TECHNICAL BULLETIN

Mini

Bull. N°: 0045

USE OF WIRING HARNESS CONNECTORS

CRIMP CONNECTOR FITTING PROCEDURE:

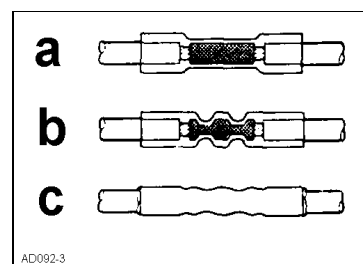
Wiring repairs/connections - uncertainty of correct method.

Unsuitable wiring connectors used for wiring repair resulting in subsequent failure in service.

If wiring rectification is considered necessary and the existing wiring section or connector cannot be replaced, an approved crimp type connector can be used.

The connectors are available in 3 sizes and must be selected to match cable size, the correct fitting procedure must also be applied.

- Crimping tool (with colour and crimp size identification).
 - Heat gun.
1. Strip wires 7.5mm and insert into crimp barrel of the correct size connector ('a' in Illustration).
 2. Match the colour and size of the crimp connector with the colour and size of the crimp cavity on the crimping tool and apply crimps 'b'.
 3. Apply heat gun to crimp connector until tubing shrinks and seals connector 'c'.

NOTE: Crimp connectors are permissible providing not more than two wires are inserted into any one cavity and connector is of adequate size for total conductor size.
